## *TECHNICAL NOTE 78.61*

### **TECHNICAL SPECIFICATIONS FOR THE RE-DESIGN OF THE COMPARTMENT III PILOT REACTOR**

Prepared by/Préparé par	Montràs, A., Pérez, J., Peiró, E. and Gòdia, F.
Reference/Référence	CCN7 to contract 13292/98/NL/MV
Issue/Edition	1
Revision/Révision	0
Date of issue/Date d'édició	20/05/07
Status/Statut	Final

**Figure 11: : Schematic overview of updated compartment III.**

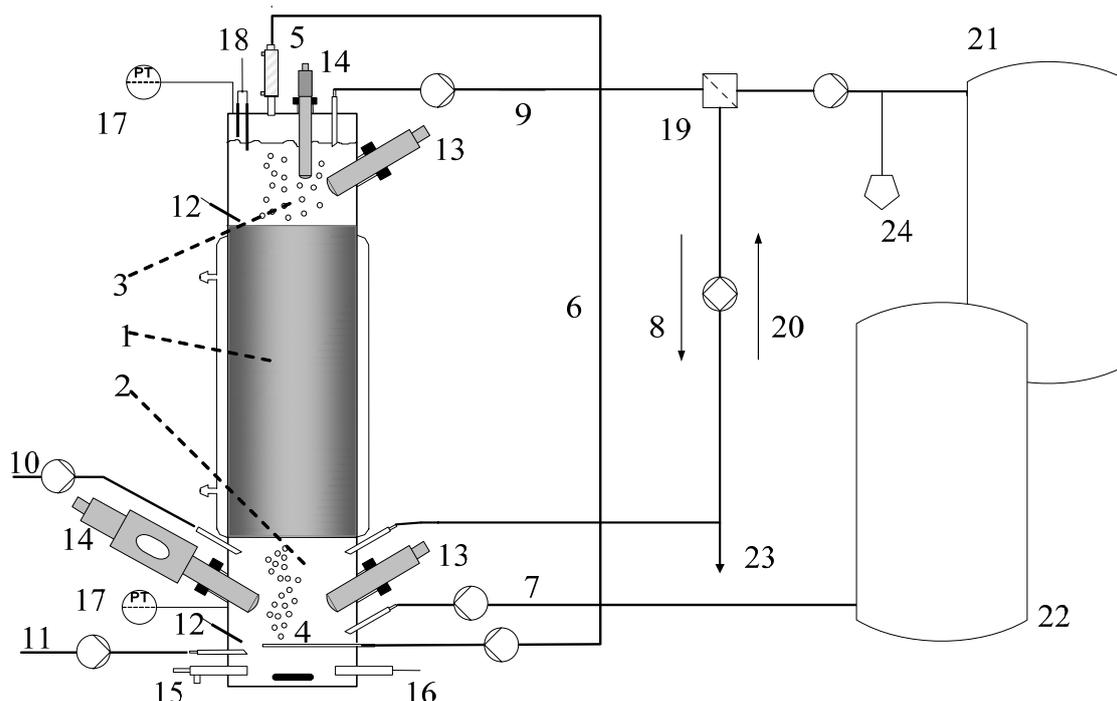
In this frame of work, precise contents and limits of delivery, in term of hardware, are not fully clear. Maybe a functional scheme, or a flow scheme or general PID could bring some clarification (especially with regards to future connection to other Compartments which seems not to be taken into account).

A general scheme is included (Fig. 11, page 26).
